## Objection to Stage 1 DA for SSD 7874

### Redevelopment of the Harbourside Shopping Centre

Prepared on behalf of the Owners of Strata Plan 49249

Analysis of Visual Effects and Impacts on One Darling Harbour

*View east from apartment 913*

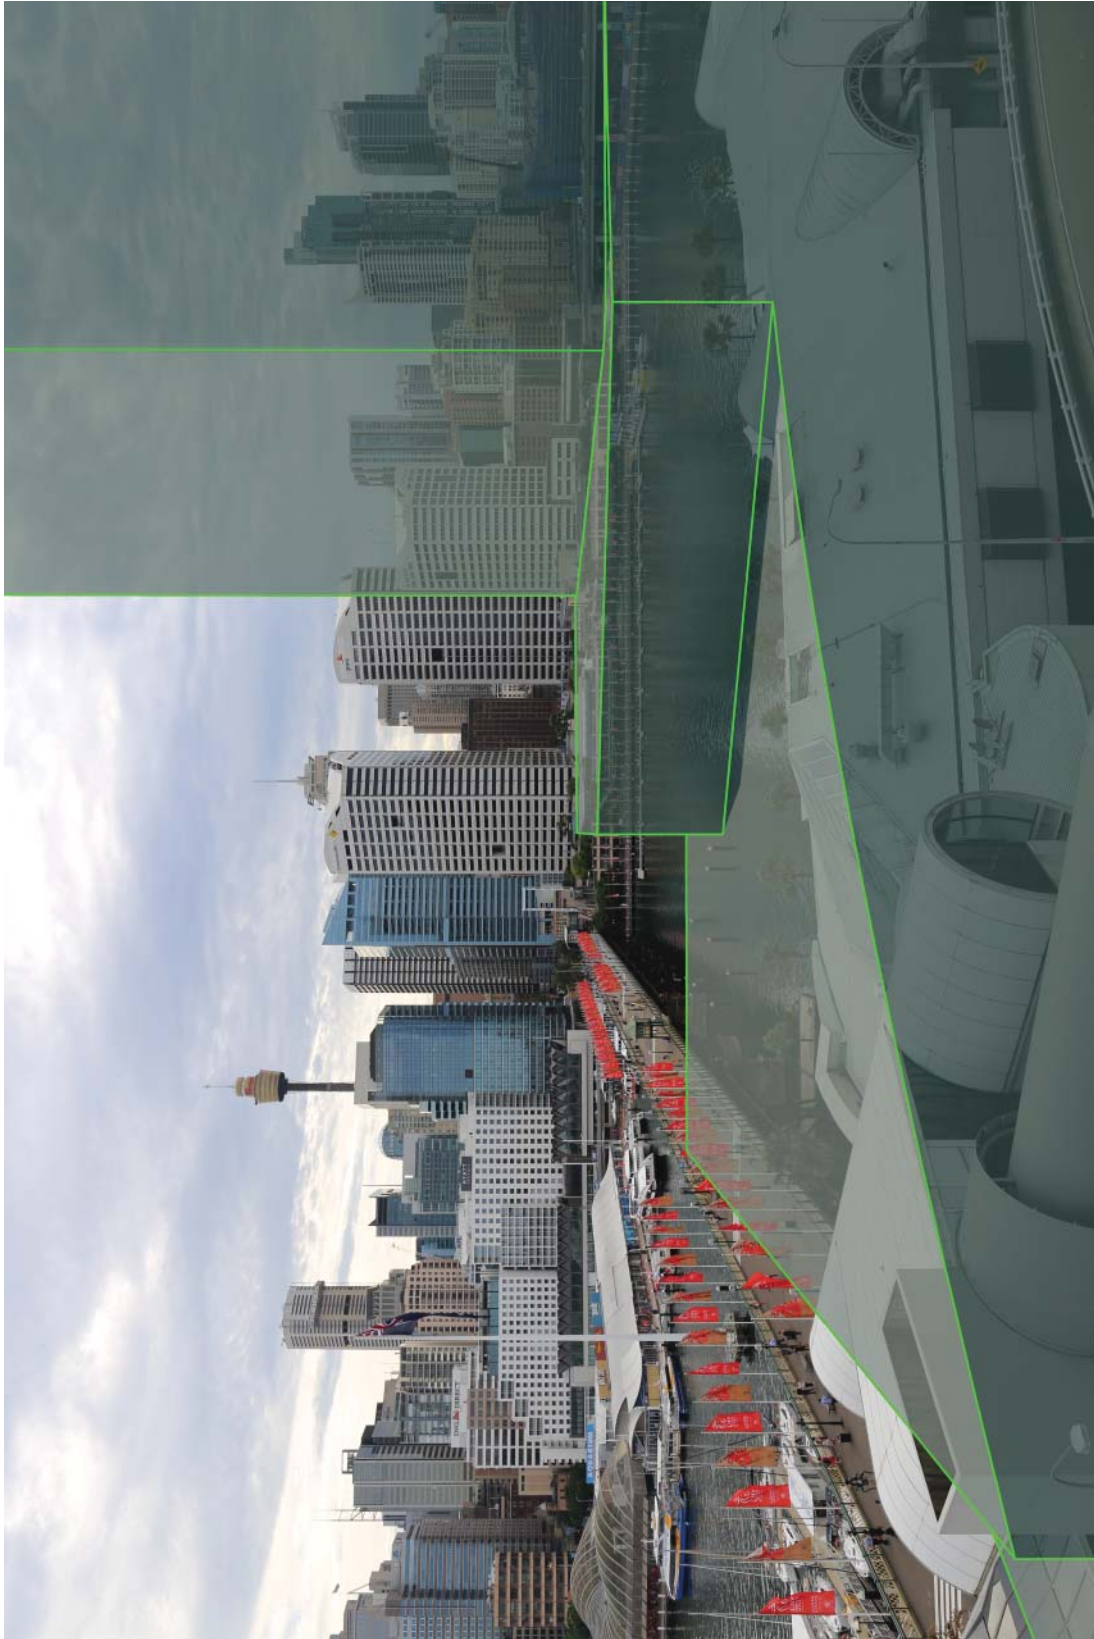
Apartment 913 is located in the northern part of the building (see Figure 3 typical floor plan 4<sup>th</sup> – 11<sup>th</sup> floor). In views from Apartment 913 view loss includes nearly 40% of the existing water view in Cockle Bay. This is a significant view loss, not a minimal impact.
